Product Change Notice/
Product Recall Notice

1. Supplier Information OFS, One BrightWave Boulevard, Carrollton, GA 30117 Contact Engineer: Diretress Sinkfield (770)838-5302 Diretress.Sinkfield@ofsoptics.com		2. Product Change/ Recall Notice No. 2011-0007-1 D	2a. Include on www.ofsoptics.com Yes

3. Issue Date of Change/Recall May 11, 2011	4. System & Product Description AccuFlex+ Round Ribbon Plenum Cables (84-96 Fibers)		
5. New Product ID AccuFlex+ Round Ribbon All Plenum PVC Cable RRC-<i>nnn</i>F-<i>xPy</i> <i>Where:</i> <i>nnn</i> is the number of fibers (084 - 096) <i>x</i> is the fiber type <i>y</i> is the jacket color	6. Old Product ID Enhanced AccuFlex PLUS Round Ribbon Plenum Cable RRC-<i>nnn</i>F-<i>xPy</i> <i>Where:</i> <i>nnn</i> is the number of fibers (084 - 096) <i>x</i> is the fiber type <i>y</i> is the jacket color

Figure 1: AccuFlex+ Round Ribbon All PVC Plenum Cable (“F” Version)

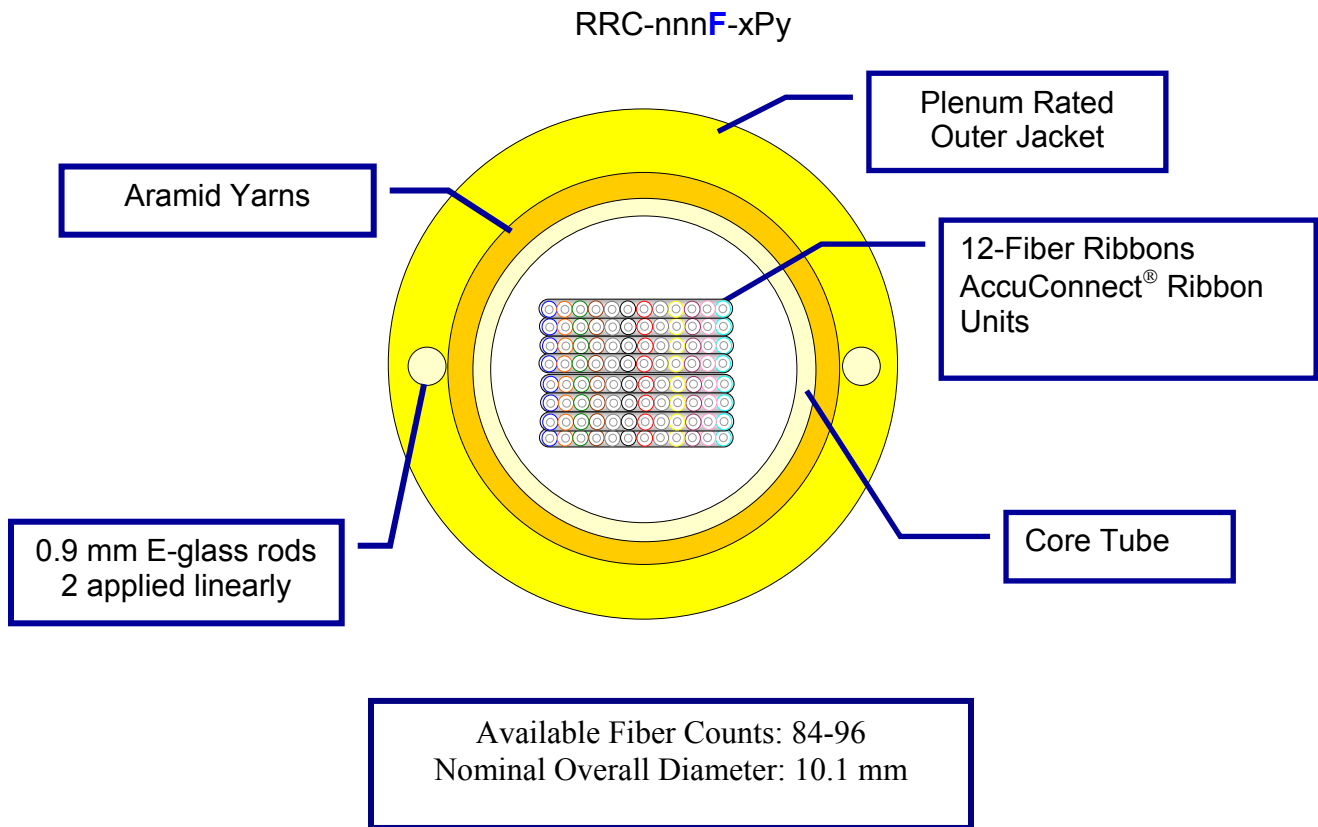
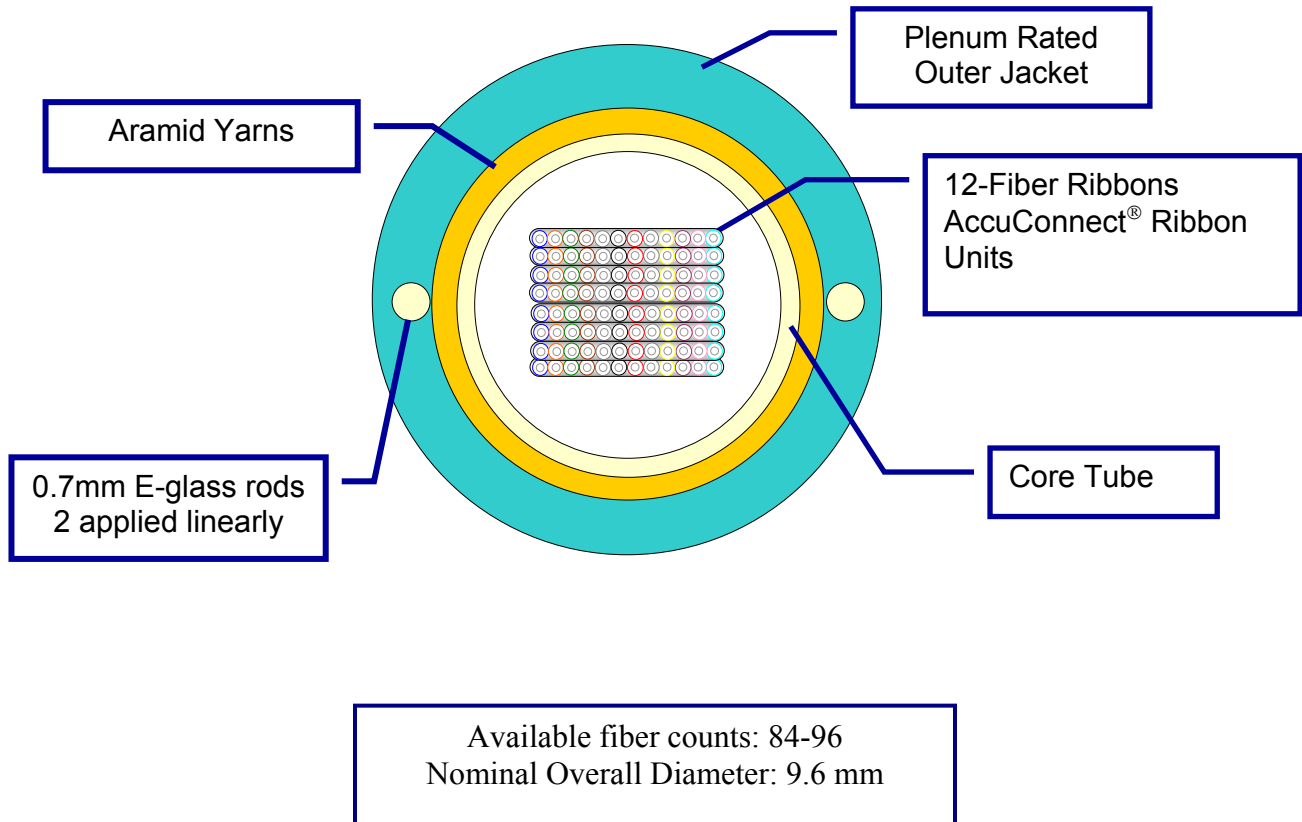
12. Description of Change/Recall New material will be used on the core tube and outer jacket on all PVC Plenum Enhanced AccuFlex PLUS cables.			
13. Effect of Change/Recall <ul style="list-style-type: none"> E-Version: 84-96 Fibers. Long lead time due to limited supply of PVDF. F-Version: 84-96 Fibers. E-glass rod change from 0.7 mm to 0.9 mm to which resulted in a larger cable diameter. Therefore, the nominal outer diameter increased from 9.6 mm to 10.1 mm. Core tube and outer jacket is manufactured with new material. Core tube and jacket material is readily available.

20. Location and Quantity of Equipment N/A
21. Attachments N/A
22. Comments <ol style="list-style-type: none"> 1) E-Version: 84-144 fibers. Long lead time due to limited supply of PVDF. F-Version: 84-96 Fibers. Core tube and outer jacket is manufactured with new material. E-glass rod change from 0.7 mm to 0.9 mm which results in a larger cable diameter. Therefore, the nominal outer diameter increased from 9.6 mm to 10.2 mm. Core tube and jacket material is readily available. 2) Samples are available upon request. 3) Refer to Table 1 for affected products 4) Refer to Figure 1 and Figure 2 for the cable's cross section.
